Re: LeBreton Flats Library Parcel – 665 Albert Street, City of Ottawa
Booth Street and Albert Street NE Roadside Safety Assessment
TYLin Ref. 10399

MEMORANDUM

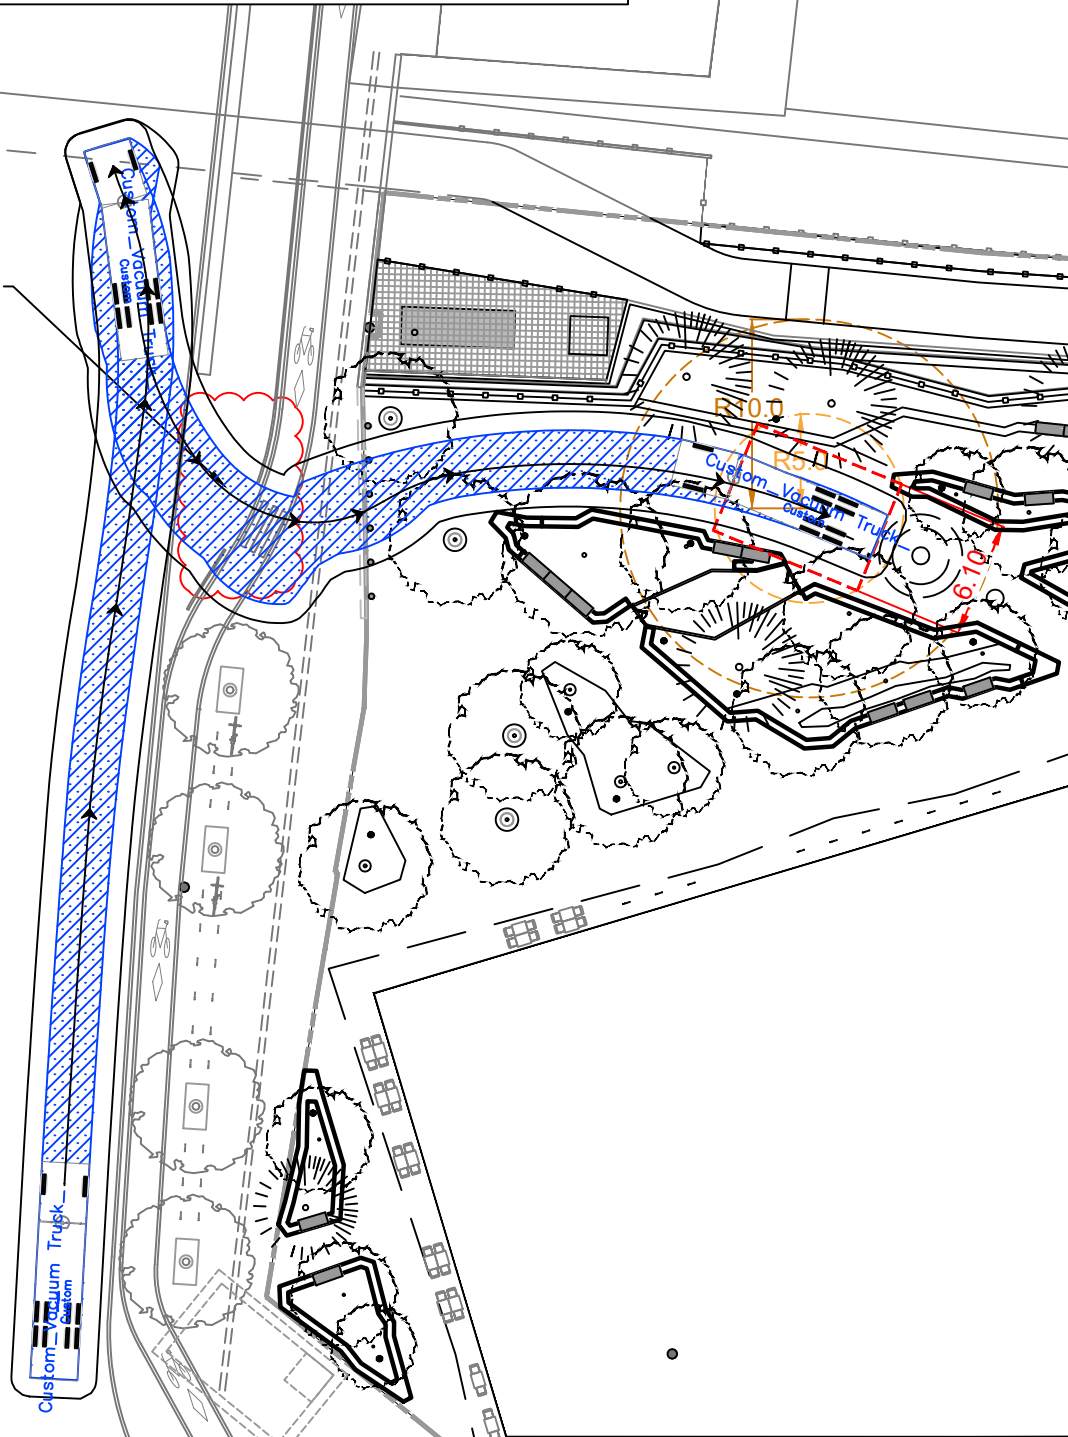
Recommend to install tall planter boxes to provide physical separation between the roadway and public realm.

Recommend hatched pavement along the curbside edge of the roadway to reduce the widths of driving lanes along Booth Street. Additional safety measure such as removable lane separators may be considered within the hatched area. Both recommended measures are low-cost solutions in lieu of full curb reconstruction, and would serve as traffic calming measures to slow vehicular speeds and enhance the safety of cyclists in the adjacent bike lane within the public right-of-way.

Consider installing Curb Reflectors along the curb radius to improve the visibility of the curb and entrance into a traffic-calmed roadway during low-light conditions.

TYLin recommends the installation of 6-7 removable bollards within the property line to enhance multi-modal safety within Pimisi Plaza and replace the existing function of the concrete parapet, which will be removed.

The bollards are required to be removable, to accommodate service vehicles which require periodic access along this route to the wet well. The truck swept path analysis is enclosed as a separate drawing for reference.

Bollards have been discussed with the Landscape Architect and are included in the landscape base plan. These may be designed to be visually consistent with the adjacent public realm.

QMC 4037R Boom Truck (N.T.S.)			
meters			
Tractor Width	: 2.50	Lock to Lock Time	: 6.0
Trailer Width	: 2.50	Steering Angle	: 48.0
Tractor Track	: 2.50	Articulating Angle	: 70.0
Trailer Track	: 2.50

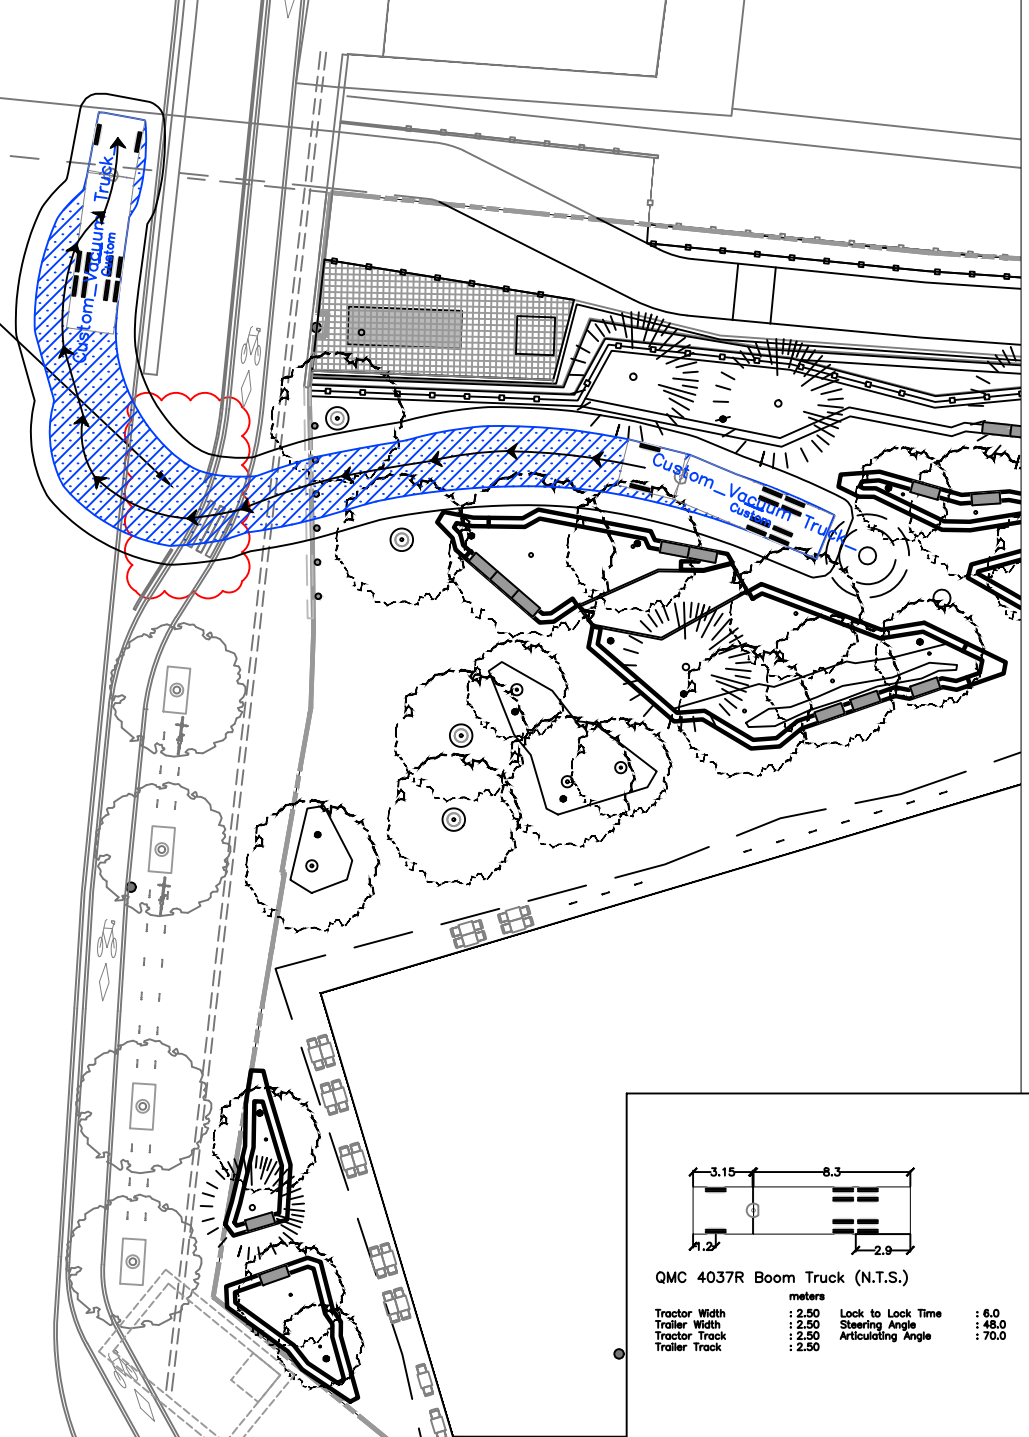
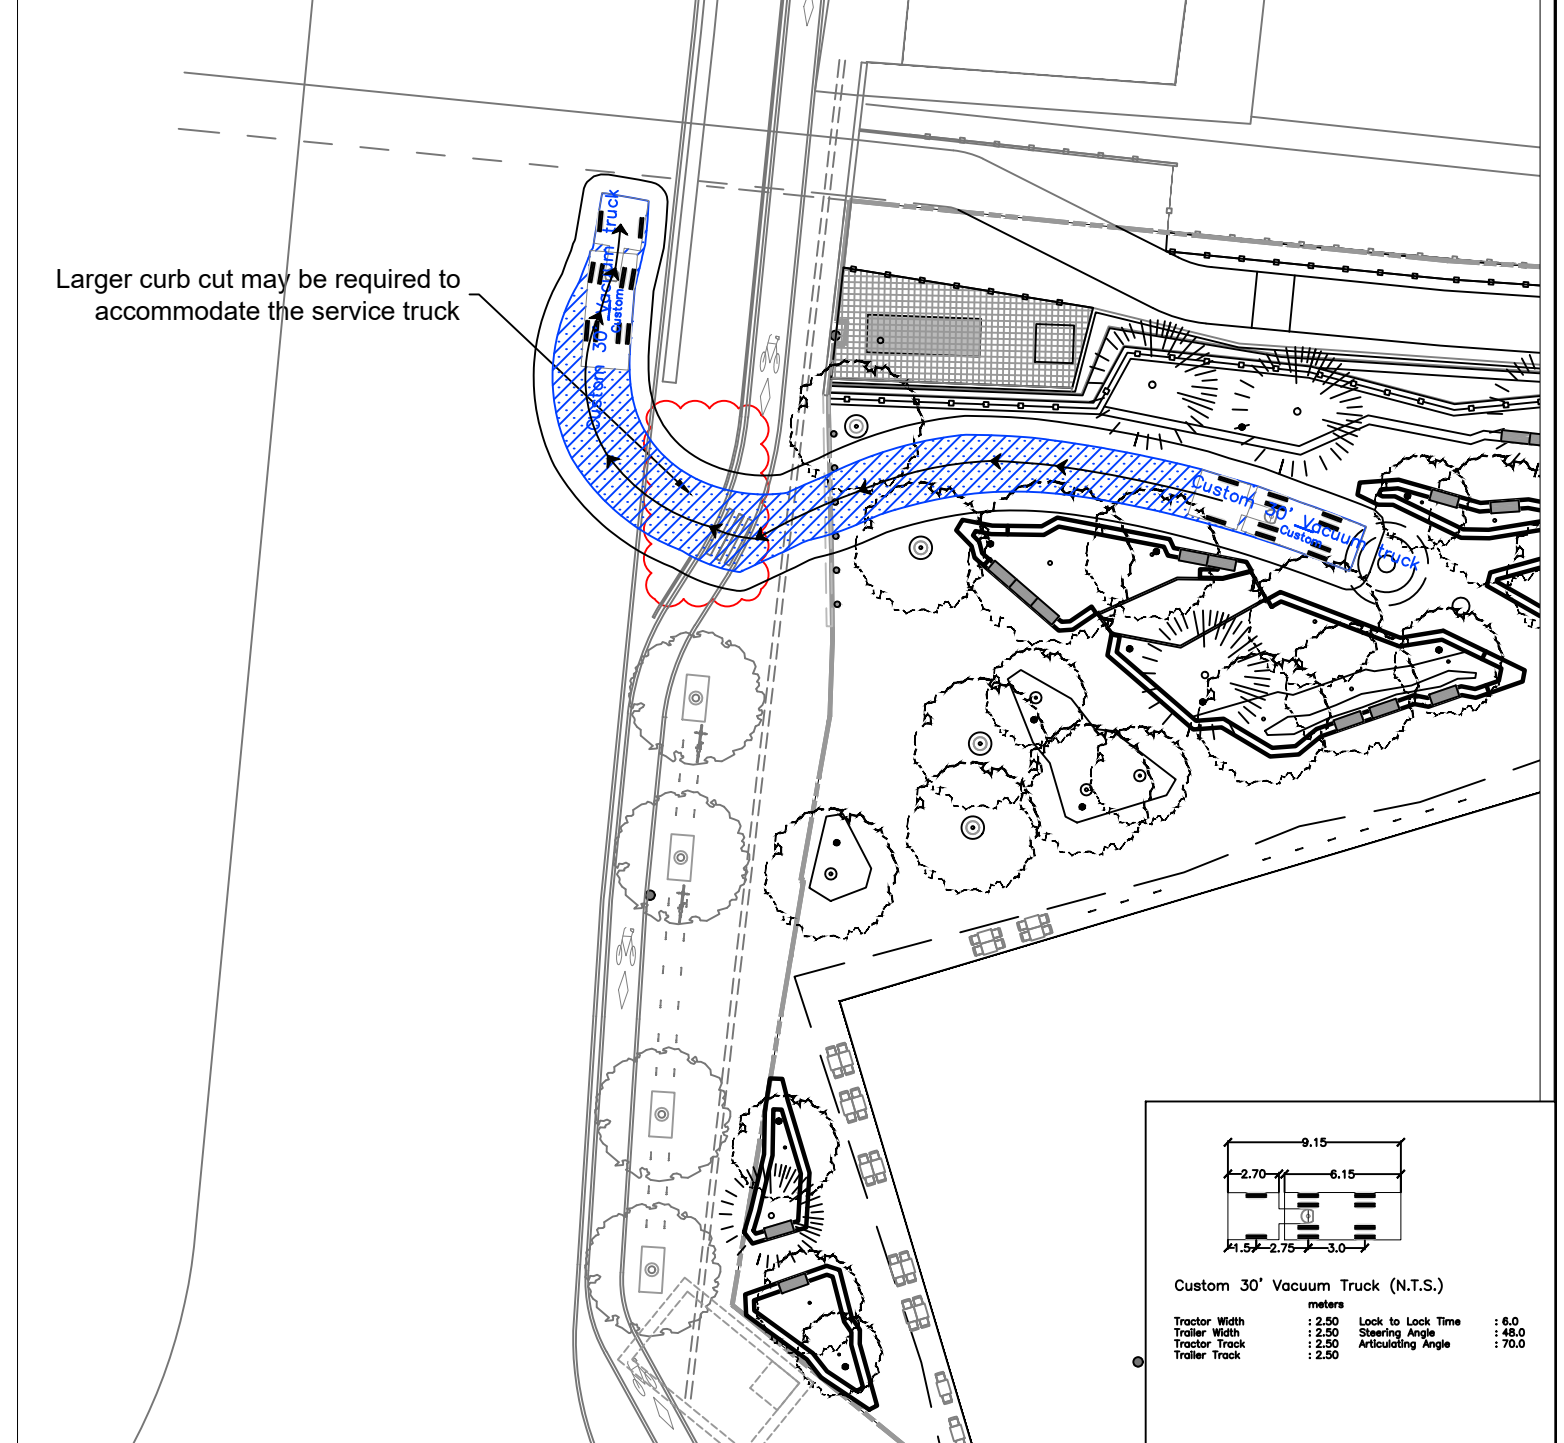
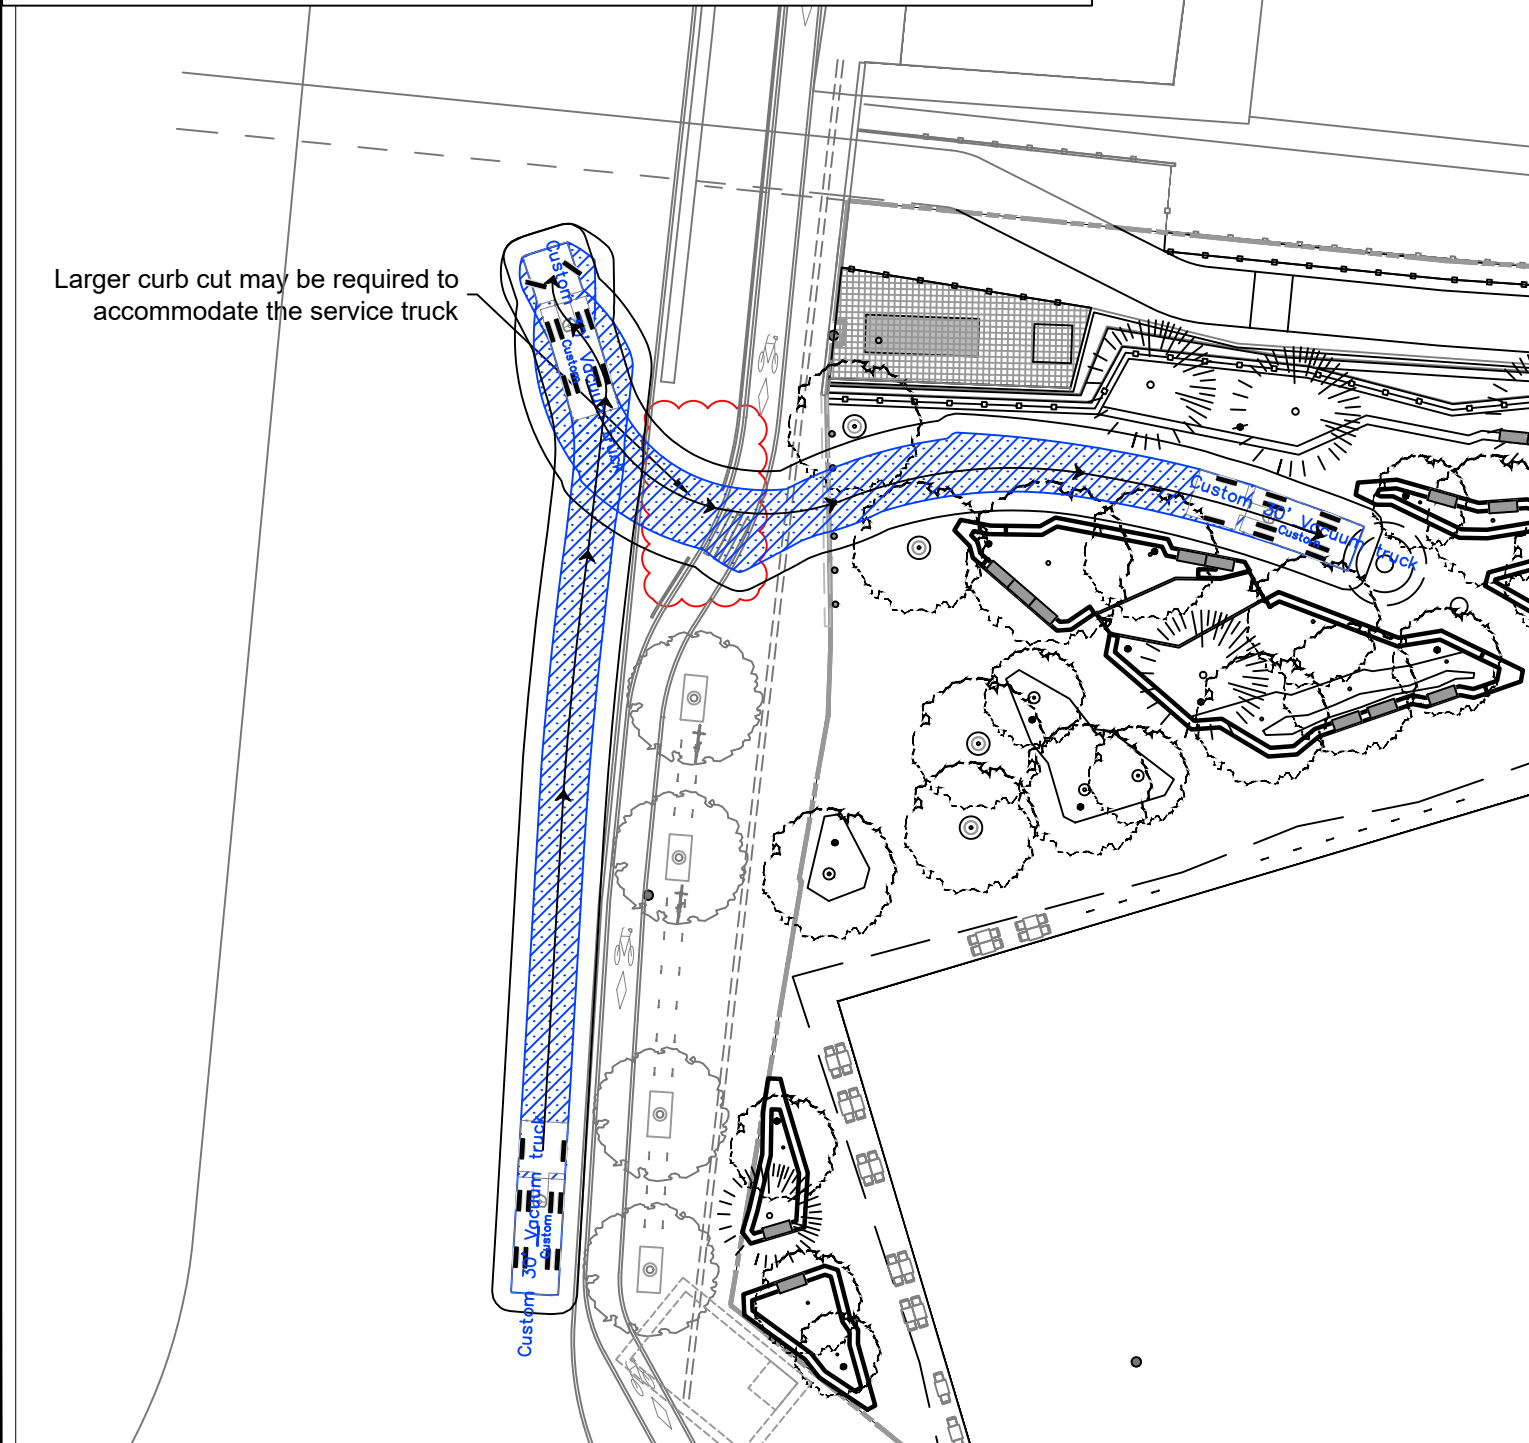
Please note that the design vehicle used for the simulation may be different than the operating vehicle. A custom boom truck was created based on the truck specs provided from their partners. Please confirm if the design vehicle's detail dimensions and specs corresponds to the operating vehicle on site.

- 1.0m horizontal buffer was considered throughout the truck swept path
- It is strongly recommended that trained staffs from the city or property management staffs be present to assist circulation of the service truck. The truck will reverse in to the pedestrian realm from a public road, therefore vulnerable users shall be warned during this operation.

Larger curb cut may be required to accommodate the service truck

Larger curb cut may be required to accommodate the service truck

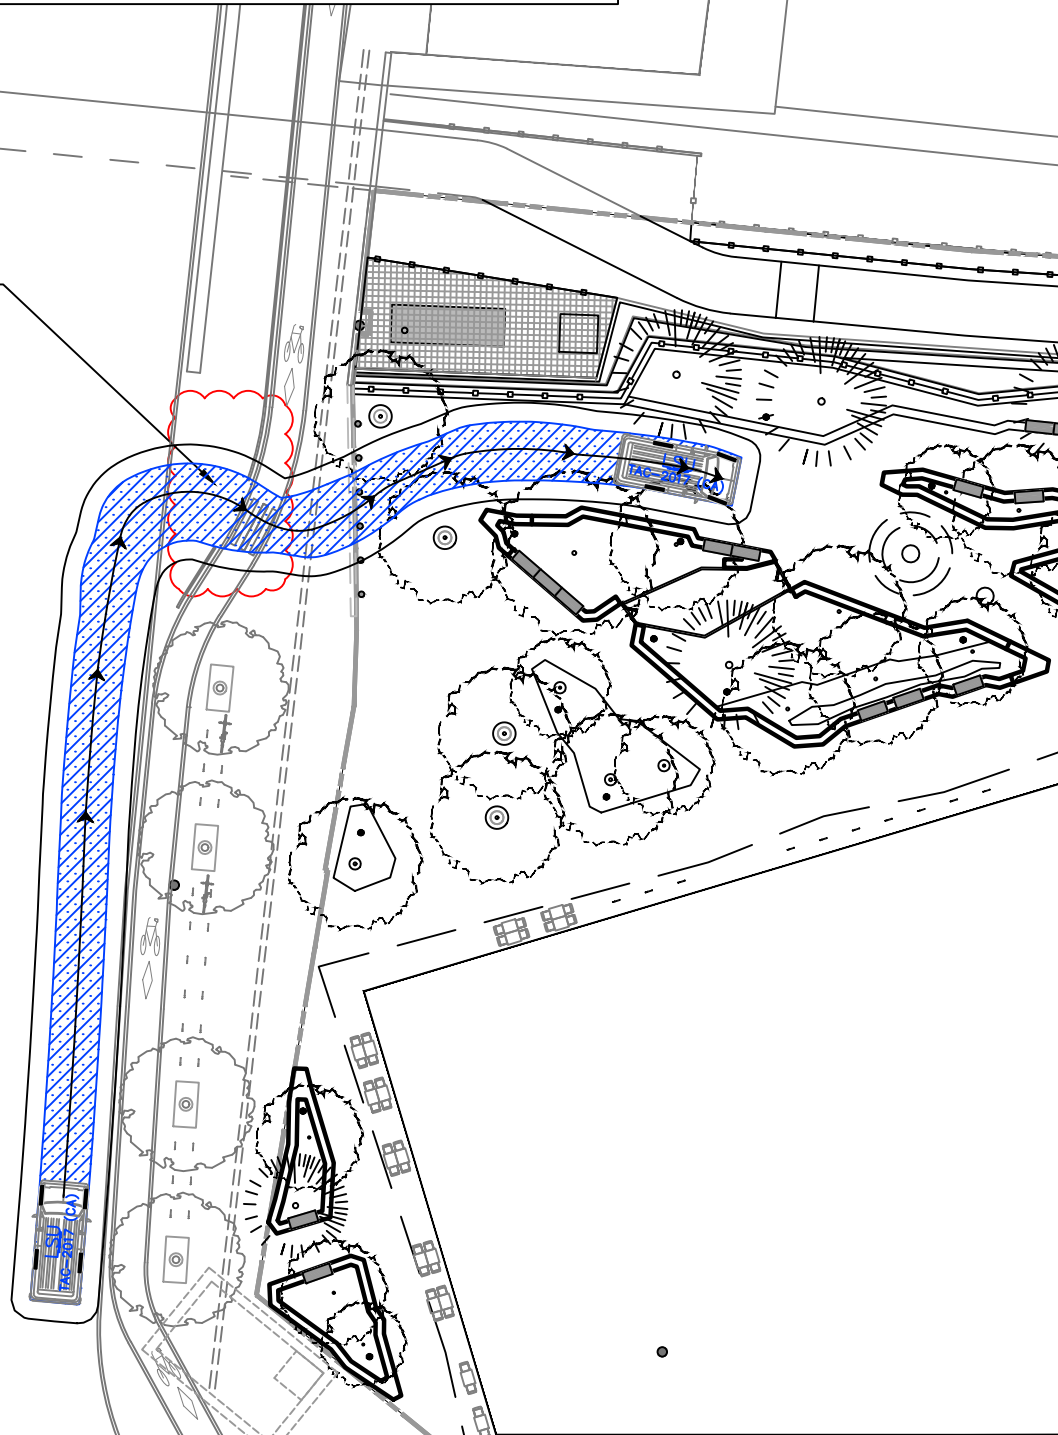
Please note that the design vehicle used for the simulation may be different than the operating vehicle. A custom vacuum truck was created based on the length of the truck provided by their partners. Please confirm if the design vehicle's detail dimensions and specs corresponds to the operating vehicle on site.

- 1.0m horizontal buffer was considered throughout the truck swept path
- It is strongly recommended that trained staffs from the city or property management staffs be present to assist circulation of the service truck. The truck will reverse in to the pedestrian realm from a public road, therefore vulnerable users shall be warned during this operation.

Larger curb cut may be required to accommodate the service truck

Larger curb cut may be required to accommodate the service truck
